Ltr requesting change to Tech Specs and trans the following....

H. B. ROBINSON UNIT NO. 2
LICENSE DPR-23

EXTENSION OF CYCLE 2 OPERATING LIFETIME

FIGURE 1

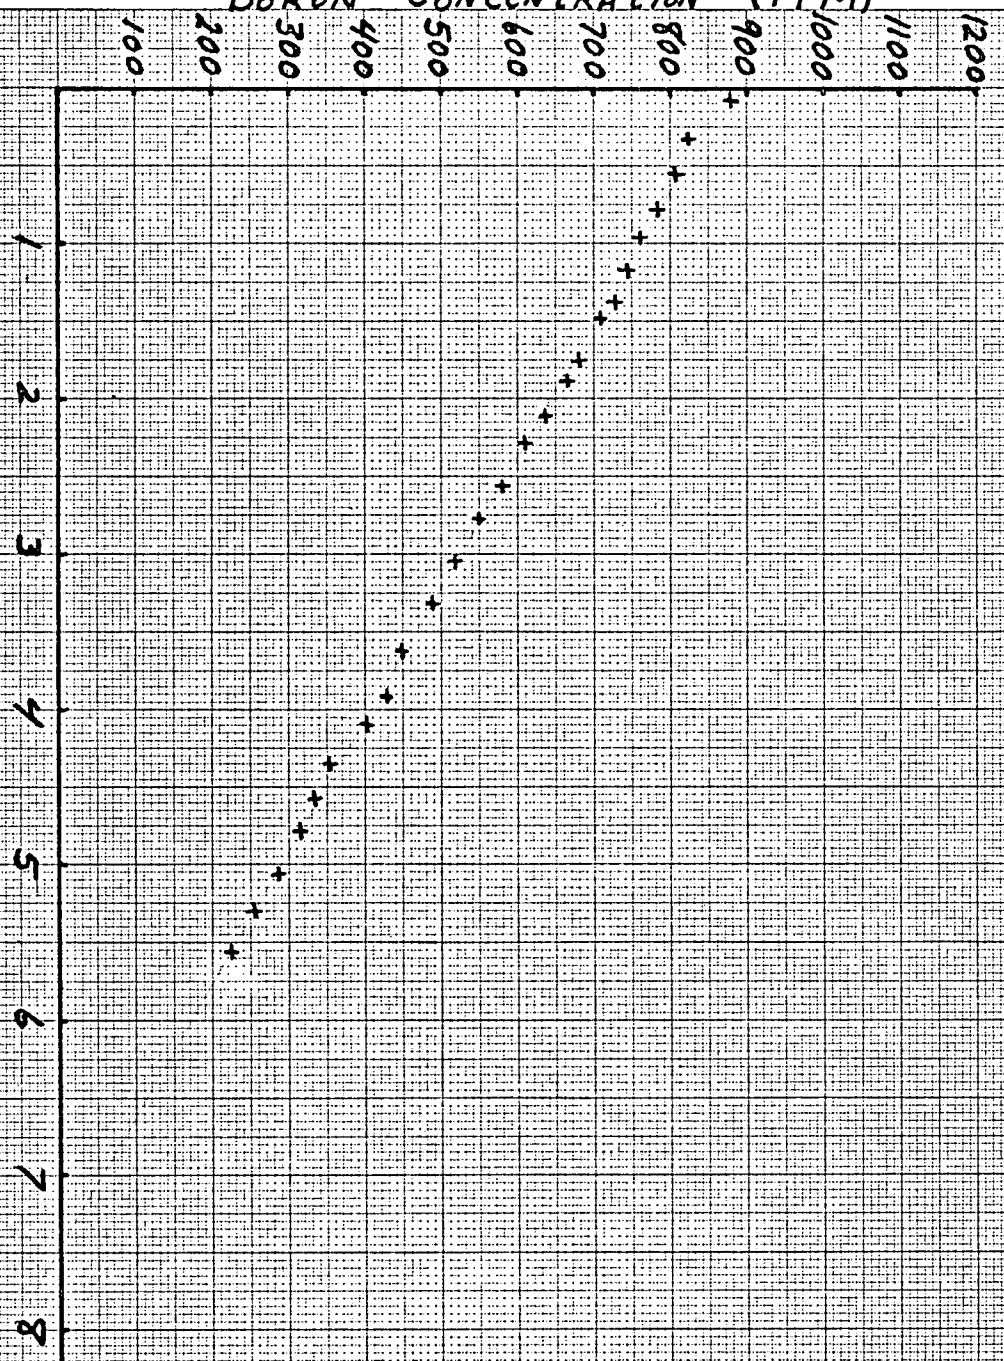
All of the other accidents have been analyzed previously in WCAP-8114, and exhibit little, if any, dependence on cycle length. As stated in Section 5.4.1 of the report, the limiting values of kw/ft for collapsed fuel rods from the standpoint of LOCA analyses is essentially independent of time; thus, no change in peaking factor limitations would be required for the additional period of operation. For the rod ejection accident, little change is expected in core power distribution for the period; thus, the results of the rod ejection analyses would not change appreciably. In addition, the most limiting case was at the beginning of Cycle 2, with substantial margin to centerline melting present at the end of cycle. In the case of the steam line break accident, there is a weak dependence of shutdown margin on fuel depletion alone; the decrease in shutdown margin due to changes in the moderator temperature coefficient and the hot standby control rod worth is less than $0.02\% \Delta\rho$, thus reducing the available shutdown margin to $2.25\% \Delta\rho$. This is still greater than the required shutdown margin of $2.20\% \Delta\rho$ specified in Section 3.10 of the Technical Specifications.

FIGURE 2

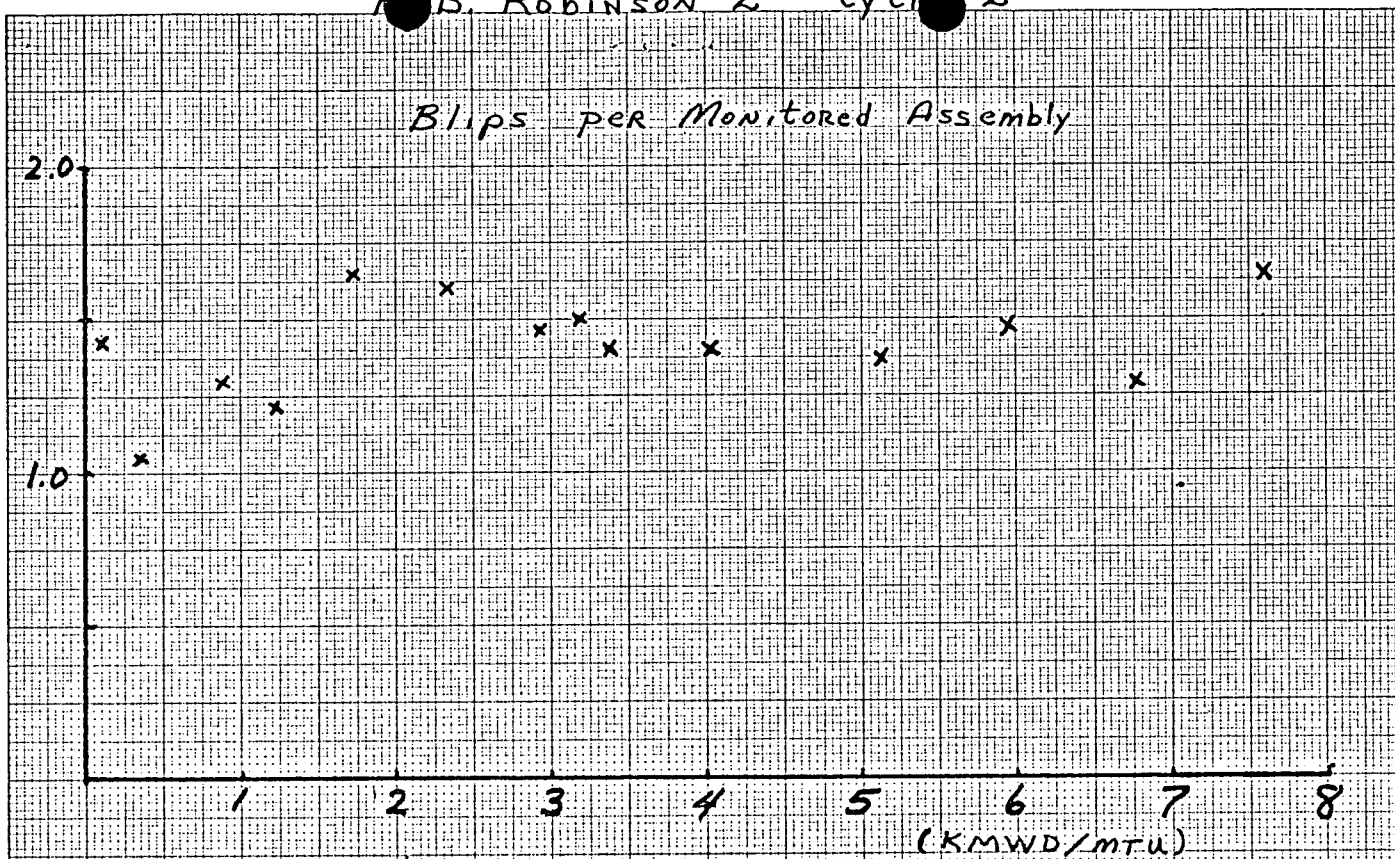
A close scrutiny of incore movable flux traces during Cycle 2 has revealed little change in the characteristics of the flux "blips" which are representative of fuel densification. The number of blips per monitored assembly (there are 46 assemblies which contain incore detector thimbles) has remained essentially constant at approximately two, as may be seen from Figure 2. This indicates that densification was essentially complete by the beginning of Cycle 2 in fuel Regions 2 and 3. Region 4 monitored assemblies have not shown more than one blip total at any time, and that only on occasion. An additional data plot showing the fraction of blips greater than 2% is shown in Figure 3, and supports the claim that densification is not continuing.
